# Access Compliance Report

## Public Rights-of-Way

### (Curb Ramps)

Intersection ID: N/A	Main Street: LANGWELL_LN	Cross Street: INVERNESS_BAY_RD	Location: SE
ADA ID: 9CDECBA2AE01	Ramp Type: Perp	Initial Pass/Fail: Fail	Overall Compliance: No
Severity Score: 13.75			
Codes/Mitigation Info/Possible Solution		Field Measurements/Component Compliance

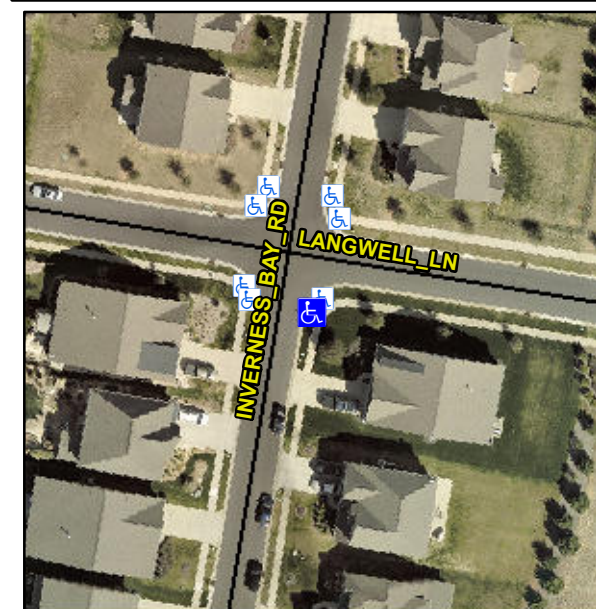
**R304.2.2, R304.5.3**

Compliance	Description	Data	Compliance	Description	Data
N/A	Ramp Length (in)	74.0	No	Ramp Slope (%)	8.8
Yes	Ramp Width (in)	48.0	No	Ramp XSlope (%)	4.4
N/A	Flare Type LT	N/A	N/A	Flare Type RT	N/A
N/A	Flare Slope LT (%)	N/A	N/A	Flare Slope RT (%)	N/A
N/A	Flare Traversable LT?	N/A	N/A	Flare Traversable RT?	N/A
N/A	Landing Length (in)	N/A	N/A	DWS Provided?	N/A
N/A	Landing Width (in)	N/A	N/A	DWS Contrast?	N/A
N/A	Landing Slope (%)	N/A	N/A	DWS Length (in)	N/A
N/A	Landing X Slope (%)	N/A	N/A	DWS Full Width?	N/A
N/A	Landing Curb? (Y/N)	N/A	N/A	DWS Offset (in)	N/A
N/A	Shared Landing?	N/A			
N/A	Gutter Ponding?	N/A	N/A	Gutter Slope (%)	N/A
N/A	Gutter Lip Ht (in)	1.0	N/A	Gutter X Slope (%)	N/A
N/A	Painted X Walk1?	No	N/A	Painted X Walk2?	N/A
	X Walk 1 Direction	To W		X Walk 2 Direction	N/A
N/A	X Walk 1 Width (in)	N/A	N/A	X Walk 2 Width (in)	N/A
	X Walk 1 Slope (%)	7.0		X Walk 2 Slope (%)	N/A
	X Walk 1 X Slope (%)	3.9		X Walk 2 X Slope (%)	N/A

**Remove & Replace Entire Ramp.**
